BUILDING PERMIT COVER PAGE

MHP 23026

TITLE SHEET
ZADORRA ESTATE INC.
CITY OF OSHAWA

MODEL:
RIVER 9
SCALE:
3/16"=1'-0"
PROJ. No.
22-16
DWG. No.
0

FLANKAGE ELEVATION 1

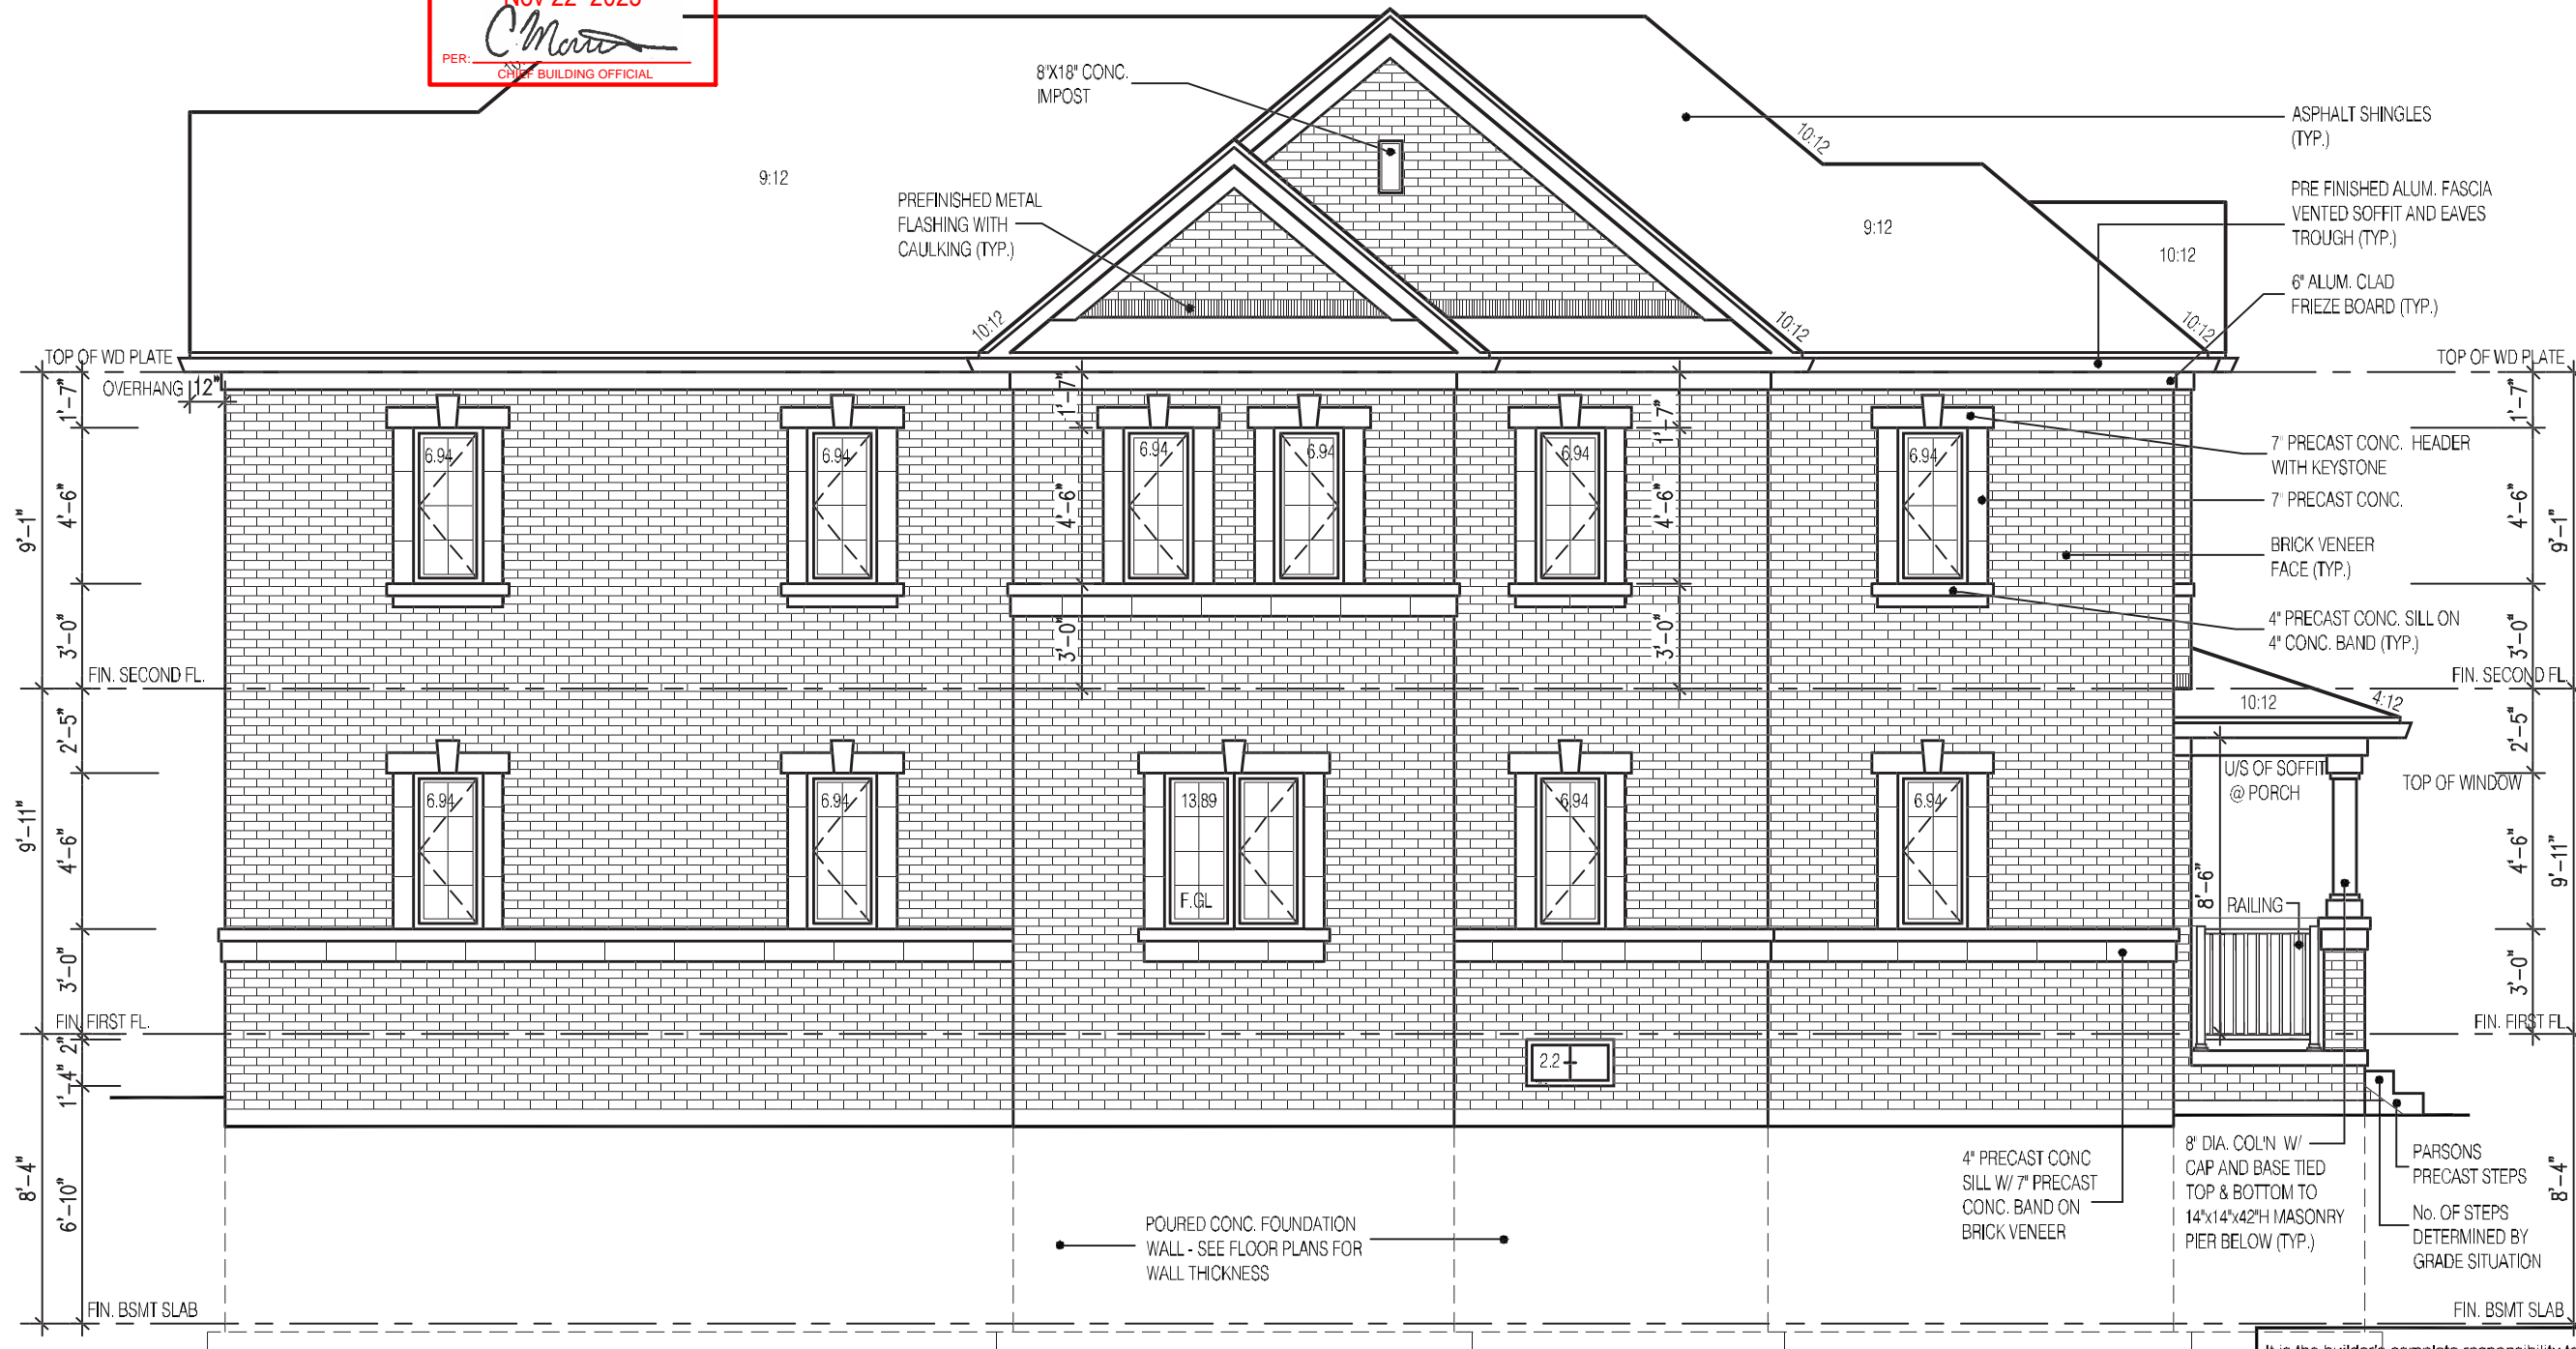
UNPROTECTED OPENINGS

WALL AREA	1231 ㎡
ALLOWABLE WINDOW AREA @ 7.0%(1.2m SIDEYARD)	86.17 ㎡
ACTUAL GLAZED AREA	85.49 ㎡ ✓
